**Subject:** Rudder gimbal drive  
-rear actuator arm-

**Affected:** Sailplane model H 301 Libelle, H 301 B Libelle  
Sailplane model Std Libelle, Std. Libelle 201 B  
Sailplane model Std Libelle 202

**Technical Note**  
**No. 301-39**  
**No. 201-35**

**D-2005-118**

301-45-13

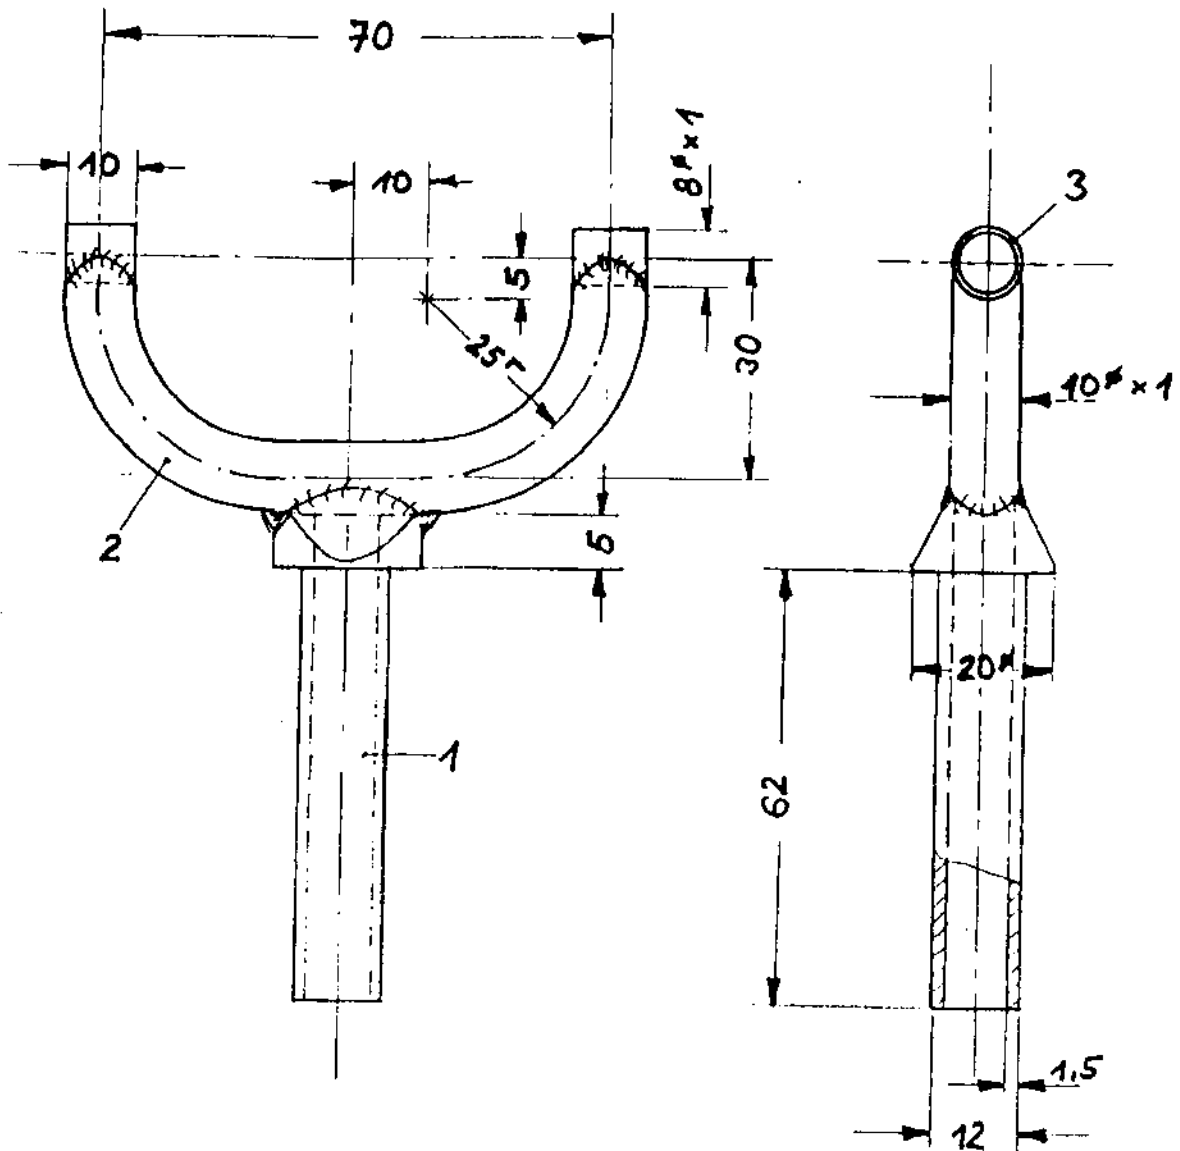
**Actions:** The faulty part, made according to drawing No. 301-45-10, must be  
replaced by an improved actuator arm, made in accordance with  
drawing No. 301-45-13  
Working instructions:

1. Remove rudder by disconnecting the tail chute, removing the M4 bolt securing the actuator arm to the rudder (located in a cavity at the lower end) and detaching the fairing between the two elevator halves.

2. Remove horizontal axle from gimbal drive by removing the castellated nut.
3. Remove both castellated nuts from rudder actuator arm and pull mounting bolts inward and off.

4. Attach new actuator arm to gimbal drive by re-inserting mounting bolts. Make sure that bolts are fully home so that bolt heads contact inner face of diagonal bushings

- also take care that the actuator arm shows no axial play when seated on these bolts, then only tighten castellated nuts lightly and secure with splint pin.

5. Re-attach rudder gimbal drive to it's mount on the lower end of the fin by inserting the horizontal axle with it's spacers. Tighten castellated nuts lightly and secure with split pin. Again, make sure that, with the assembly completed, there is no axial play, if so, proper shims must be used to eliminate the play.  
On the other hand, by overtightening the castellated nuts, stiffness or deformation of the rudder drive or a misalignment of it's axes may occur.

6. Re-attach rudder and tape it to fin when in proper position to avoid any aft movement.
7. Slide flange bushing on the actuator arm and secure in position by a wedge placed between bushing and cavity wall. Make sure that the bushings 4 mm holes are horizontal. Punch mark actuator arm on both sides at the center of the bushings 4.0 mm holes and drill arm to a diameter of 2.0 mm. With these holes properly aligned, drill to a diameter of 3.8 mm, then ream to 4.0 mm. If the 2.0 mm holes are not aligned, it is possible to use a round needle file for centering then drill and ream to proper diameter.
8. Insert locking bolt and secure with M4 stop nut.
